February 29, 2024
Project No. 20220141E001

Subject: Response to City Comments
Chase (Fused Elements) Residence
4525 Forest Avenue SE
Mercer Island, Washington

Geotechnical Report: Subsurface Exploration, Geologic Hazard, and
Geotechnical Engineering Report
Chase Residence
Mercer Island, Washington
Dated August 16, 2022

Liquefaction Analysis

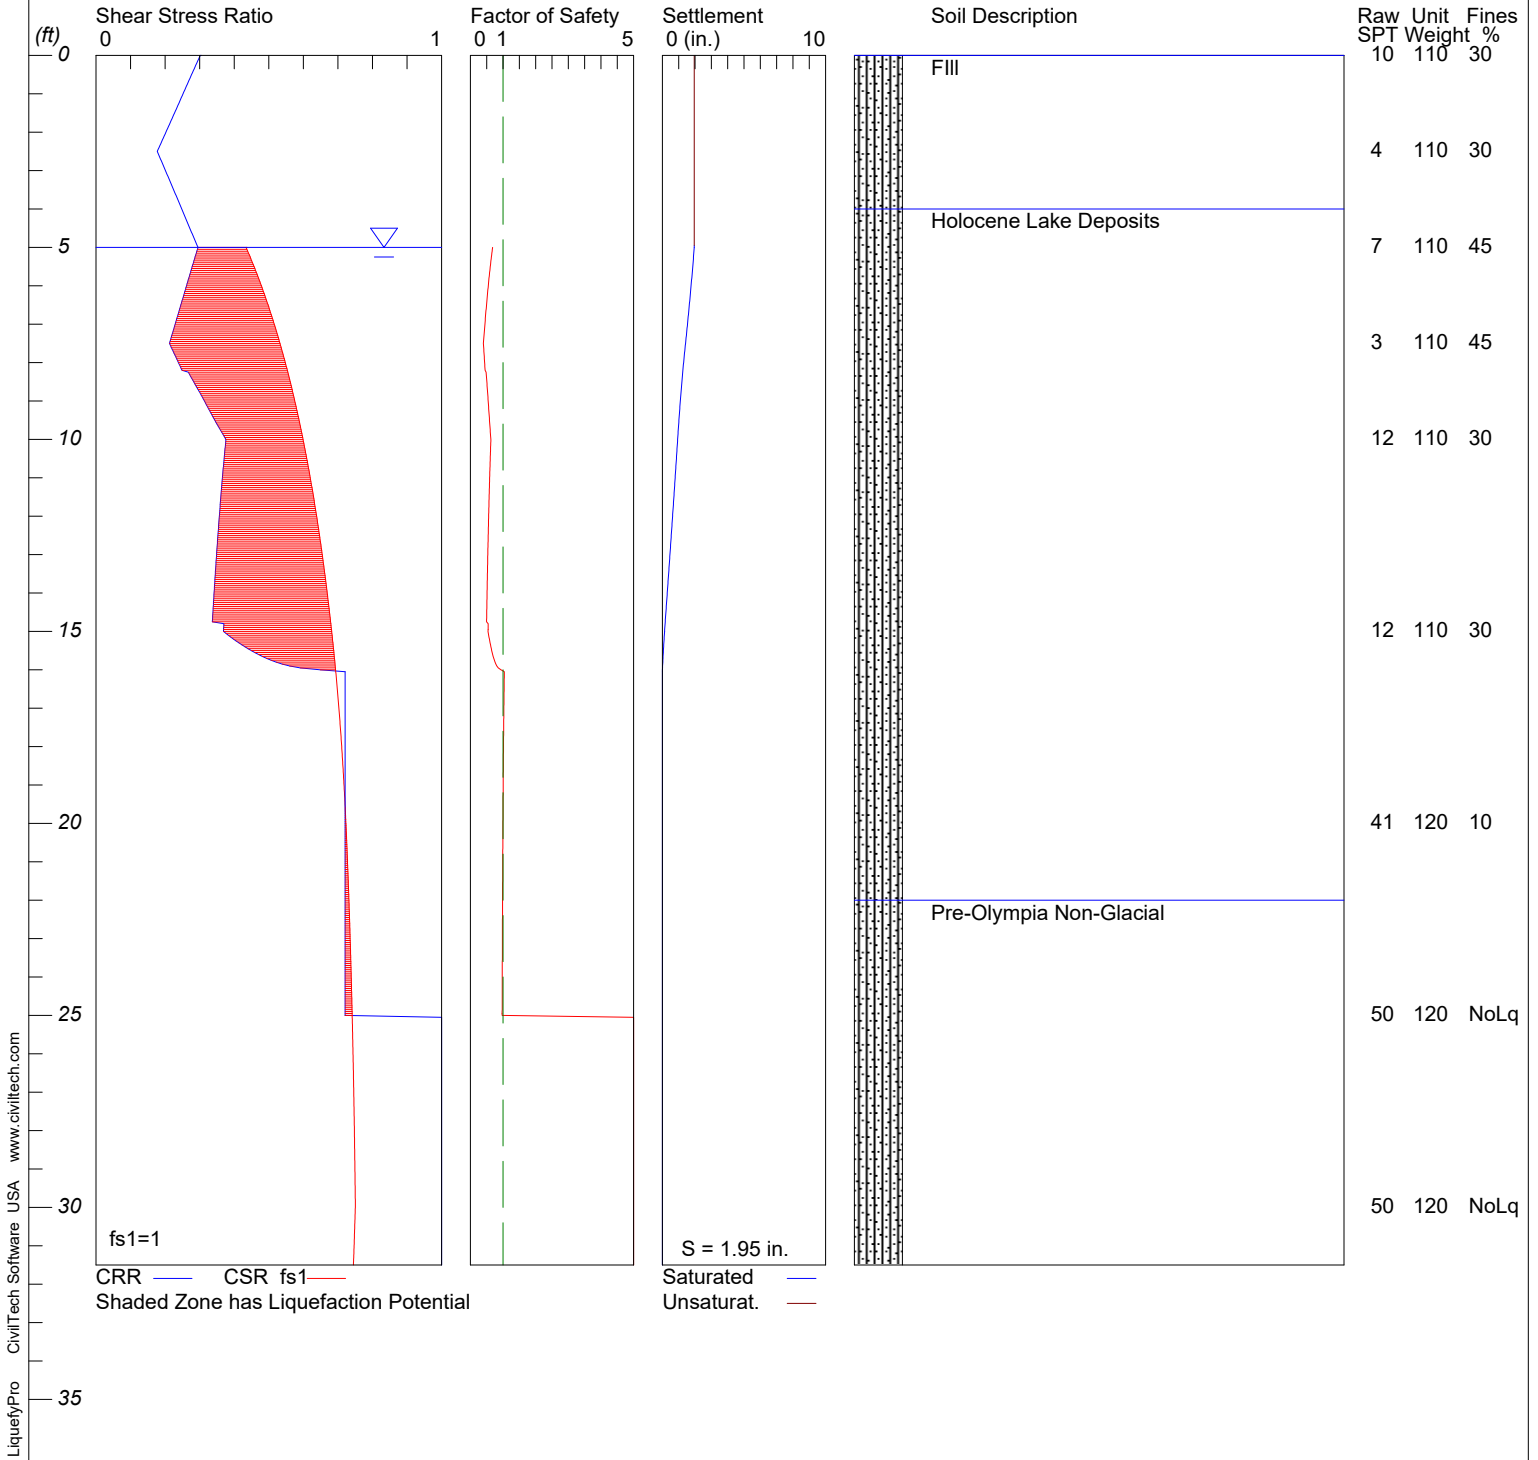
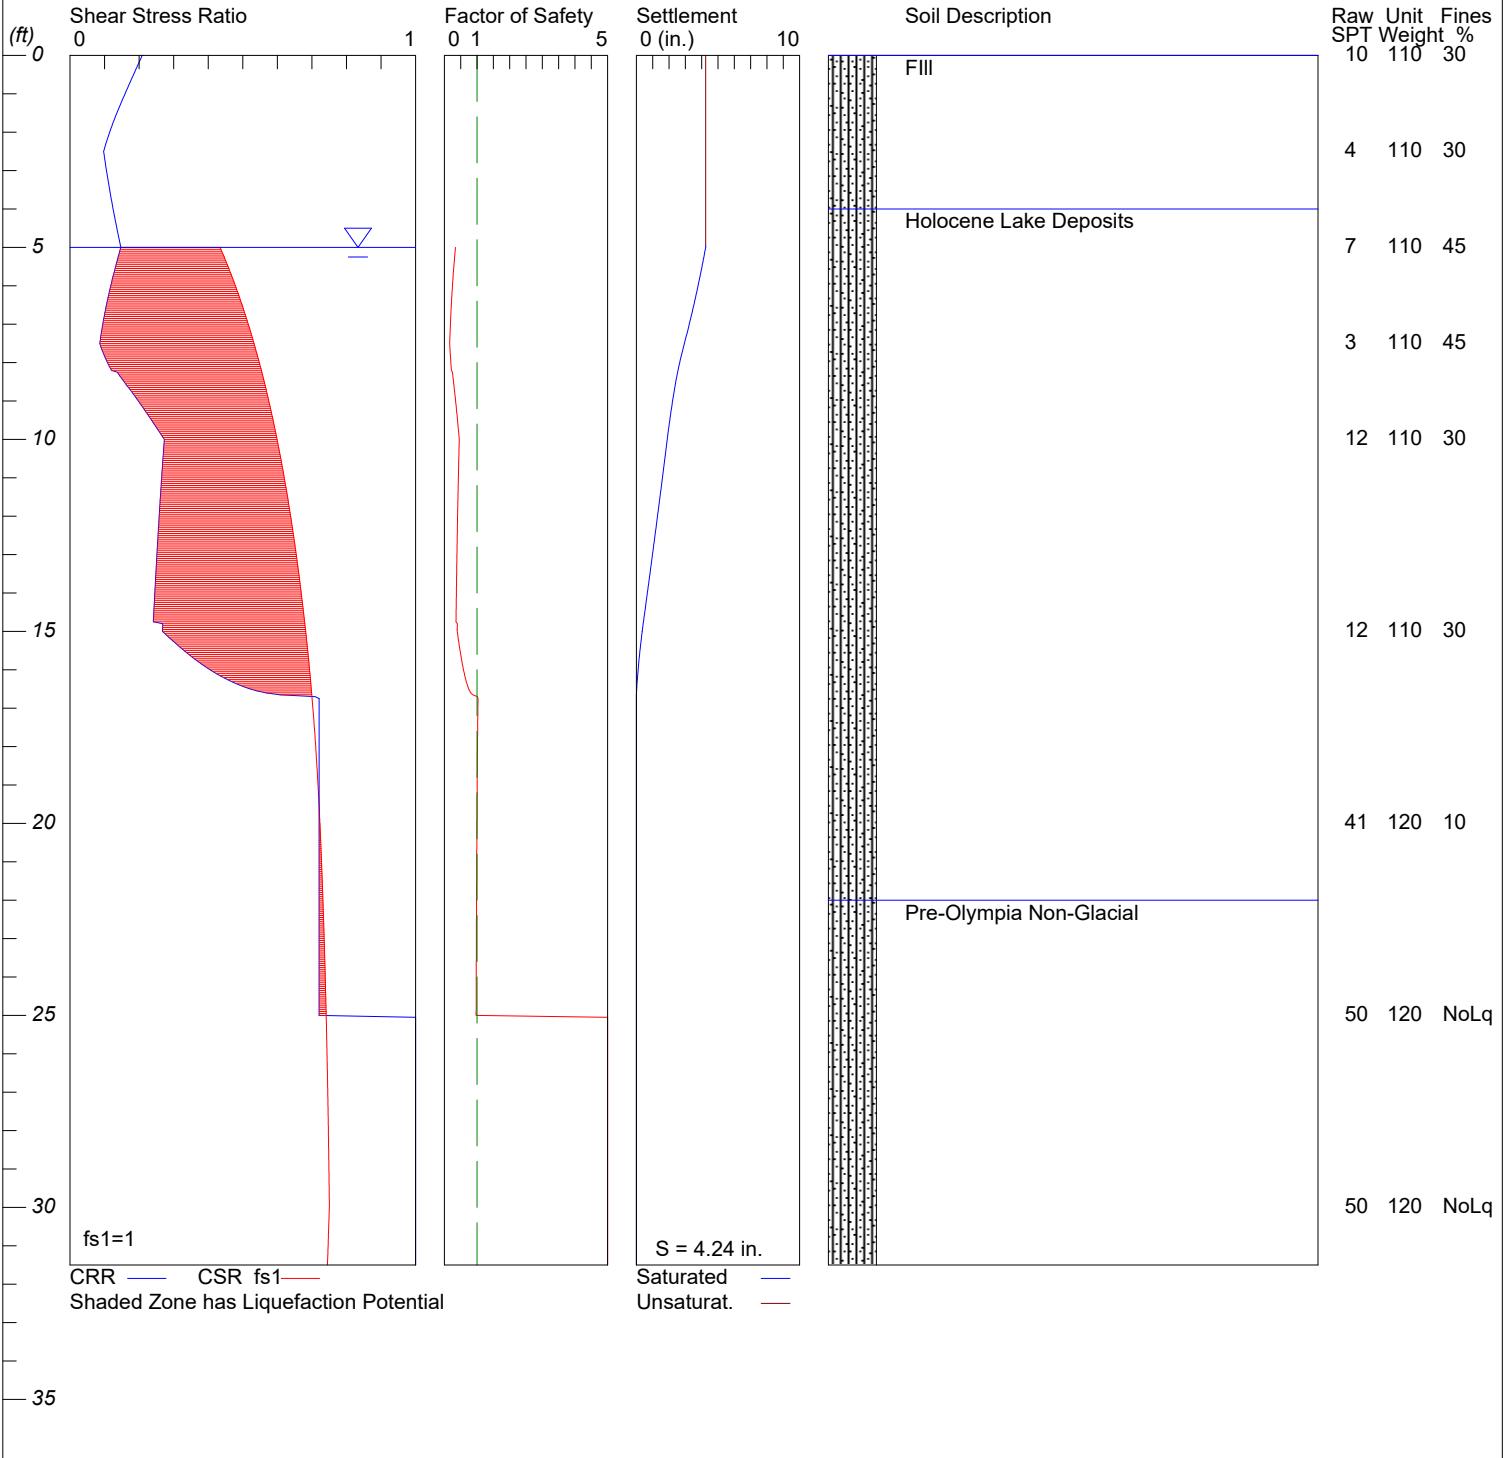
In the geotechnical report dated August 16, 2022, liquefiable soils were noted in boring EB-1. Please provide an assessment of the liquefaction potential of the site soils and potential resultant ground movements such as post-liquefaction settlement, lateral spreading or flow failure. Please provide mitigation recommendations, if appropriate. Please include calculations and relevant slope stability cross sections, analyses and results for review.

Saturated portions of the lake deposits encountered in our explorations have the potential to liquefy during a seismic event. However, the underlying dense to very dense pre-Olympia sediments are not likely to liquefy due to their dense condition. The results of a liquefaction analysis (attached) using the computer program LiquefyPro (copyright Civiltech Software), with an assumed peak horizontal ground acceleration of 0.676g, indicated a range of approximately 2.0 to 4.2 inches of potential settlement within the lake deposits encountered at EB-1, during a design level (2,475-year return period) seismic event. This range is based on values calculated using various analysis methods (Tokimatsu/Seed, Tokimatsu. M Correlation and Ishihara/

Yoshimine) and fines corrections (None, Idriss/Seed, Stark/Olson et al., and Modify Stark/Olson). The analyses predicting the lowest and highest settlement values are included in the Appendix.
